SERVICE BULLETIN

PURPOSE : INFORMATION	ISSUE NO. : MSB-06E33-001	DATE : 2006-11-20
SUBJECT : STRUT CAPS OF FRONT SUSPENSIONS FOR OUTLANDER	<div> <div><MODEL></div> <div><M/Y></div> </div> <div> <div>(EUR)OUTLANDER</div> <div>07</div> </div> <div> <div>(GS45X)(CW0W)</div> </div>	
GROUP : FRONT SUSPENSION

FRONT SUSPENSION STRUT ASSEMBLY

AC506971AB

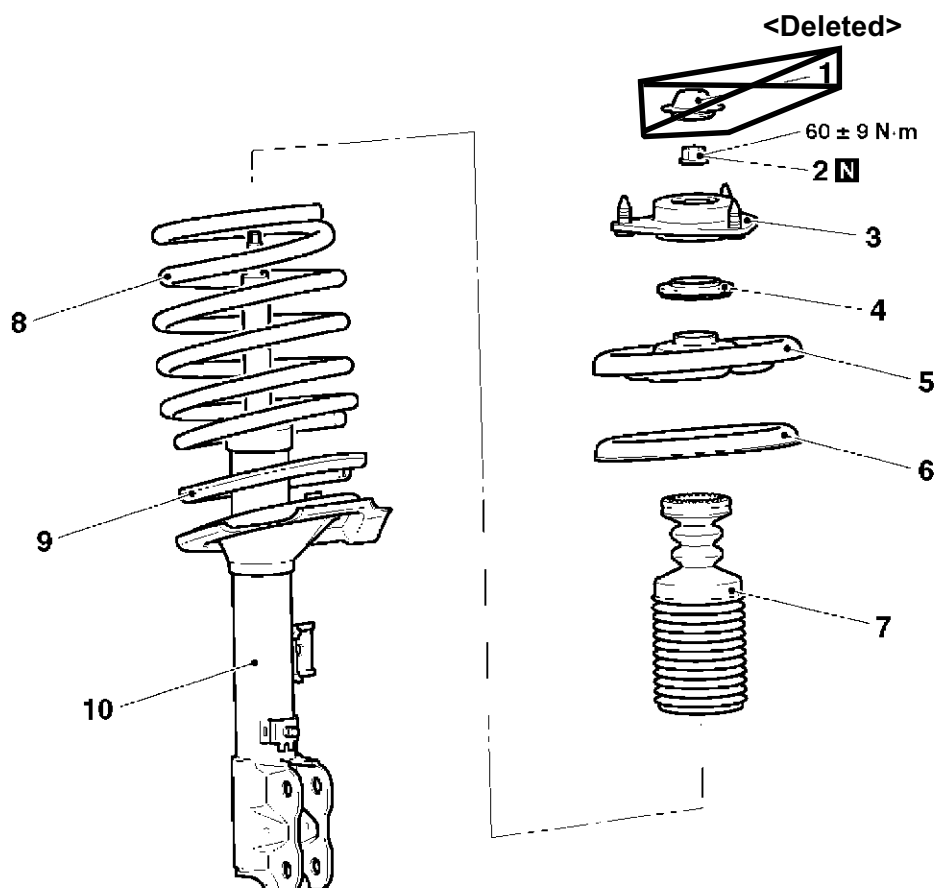
As the strut caps of the front suspensions for OUTLANDER have been abolished to reduce production costs, the related descriptions are deleted in the applicable Workshop Manual. This Service Bulletin contains the changed descriptions.

<Deleted> Disassembly steps

| <<A>> | >>C<< | 1. Strut cap |
